**RE: Amp Response to October 21, 2021 Planning Board Meeting**  
Oak Hill 1 and Oak Hill 2 Solar and Energy Storage Projects (the "Oak Hill Projects")

Thank you for providing Amp Solar Development Inc. ("Amp") the opportunity to present at the October 21, 2021 Town of Duanesburg Planning Board Meeting. Amp is using this letter to provide written responses to questions raised during and prior to the meeting. This letter also includes supplemental community responses to elaborate on some of the responses presented in Amp's October 18, 2021, Public Comment Responses letter

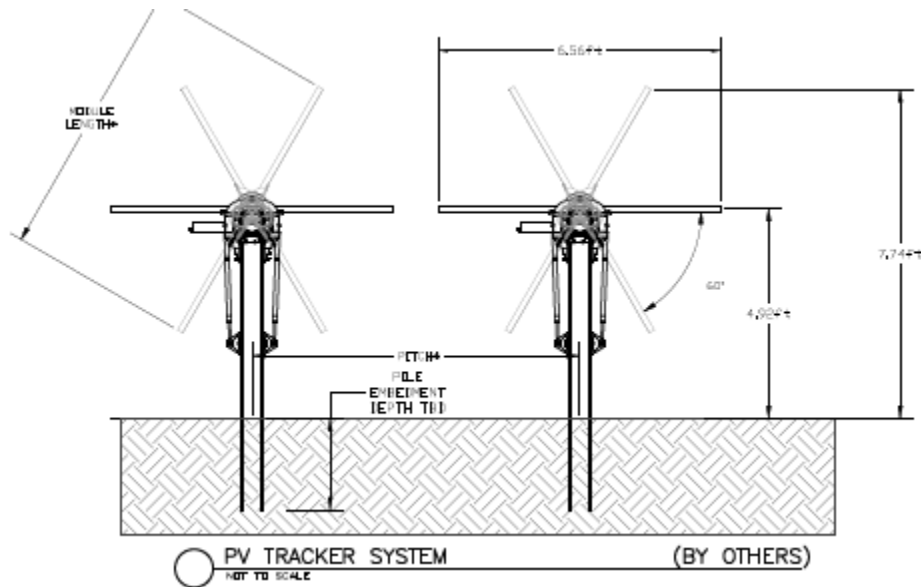
**Supplement to 73) Questions regarding the solar panels**

Images of the proposed tracking system and an image of a two-portrait tracker including a human for scale are included in 86) Comments and requests for tracker images. Amp is in the process of installing this same Schletter racking system at two (soon to be three) additional projects in the greater Albany area. Below are additional image from one of the projects currently under construction.
